This sheet transmits Revision 02 to Service Bulletin 190-22-0003.

AUTO FLIGHT - CAT IIIa AUTOLAND INSTALLATION

REVISION 02: To modify the information to execute the flight test.

FIGURE 2 - AUTOLAND OPERATIONAL TEST CARD
(SHEET 01 OF 01)

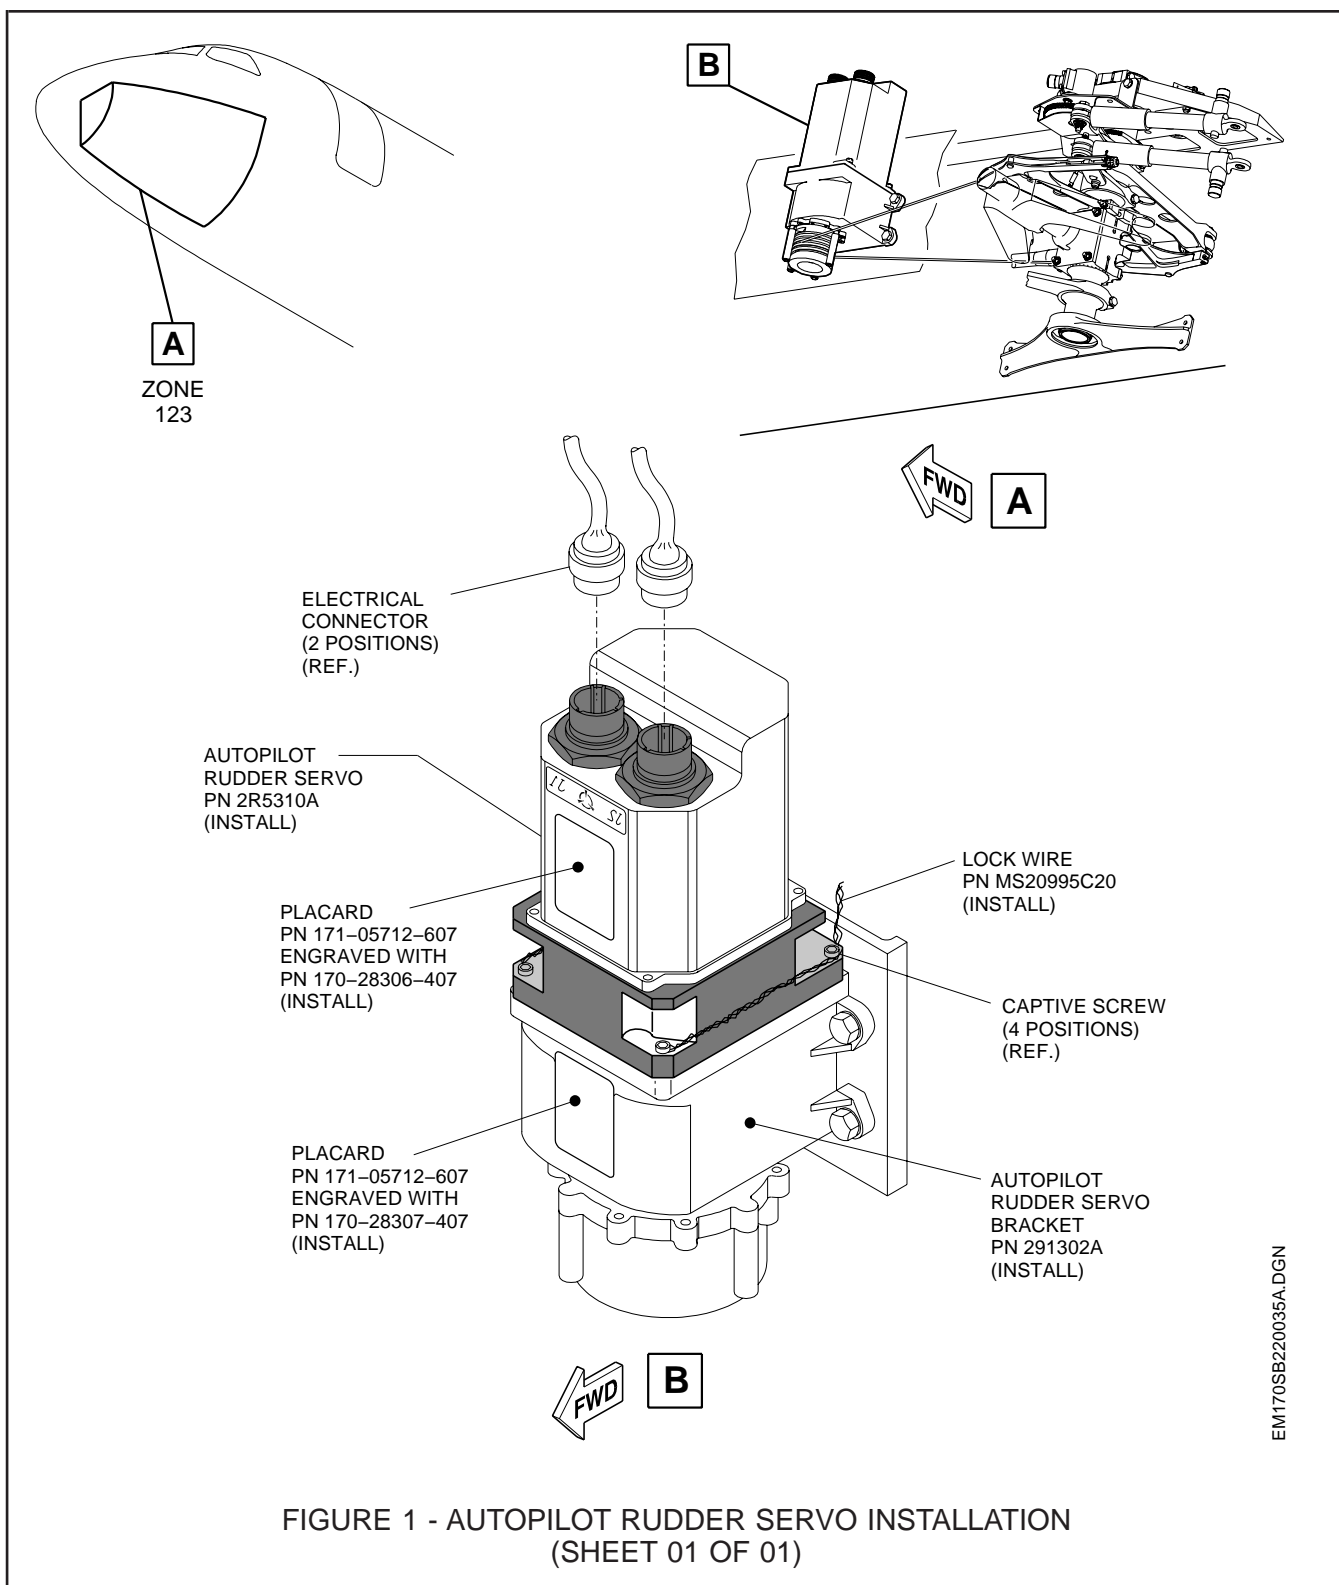
TOPIC/PAGE	DESCRIPTION OF REVISION
1. PLANNING INFORMATION	
1.C. REASON/02	Added reason for Revision 02.
3. ACCOMPLISHMENT INSTRUCTIONS	
Step 3.K./12	Corrected text to GROUND TEST.
Step 3.M./14	Included note about reason for the flight test.
FIGURES	
Figure 2 / 16	Changed figure.

NOTE: 1) This flight is intended to check the rudder servo installation since AUTOLAND operations occur in a critical flight phase.

2) The test must be conducted by a pilot qualified in AUTOLAND operation.

3) The test must be performed at an airport equipped with a Category II (CAT II) or a Category III (CAT III) Instrument Landing System (ILS) beam with Visual Meteorological Conditions (VMC).

As a reference, a flight test card is included to perform these check points. Refer to [Figure 2](#). In case the results of the test are not approved, it is necessary to contact Embraer at the address given in [2.B. INDUSTRY SUPPORT INFORMATION](#).
